Annex 5

6 Towing brackets

~~Figure 25 — example for qha towing bracket~~

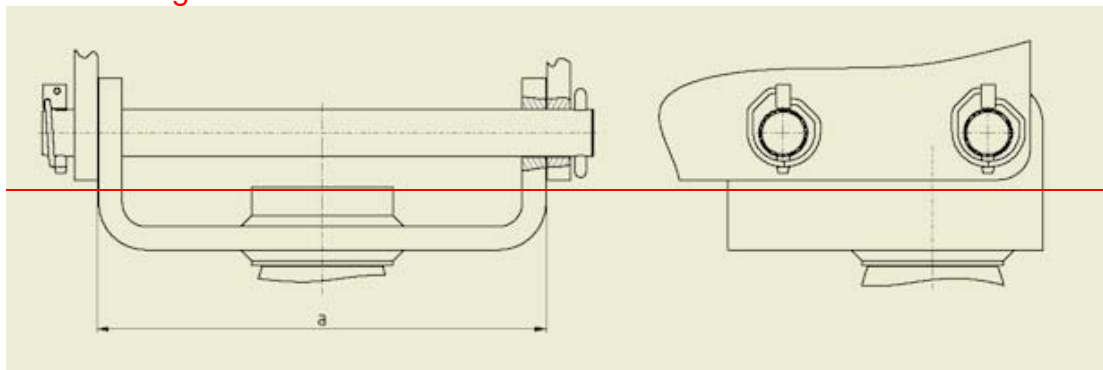
~~6.3.1 Quick height adjustable towing bracket of Class f-1 for mounting couplings of Class a80-2 and c40-2 with quick height adjustable latching rail plate.~~
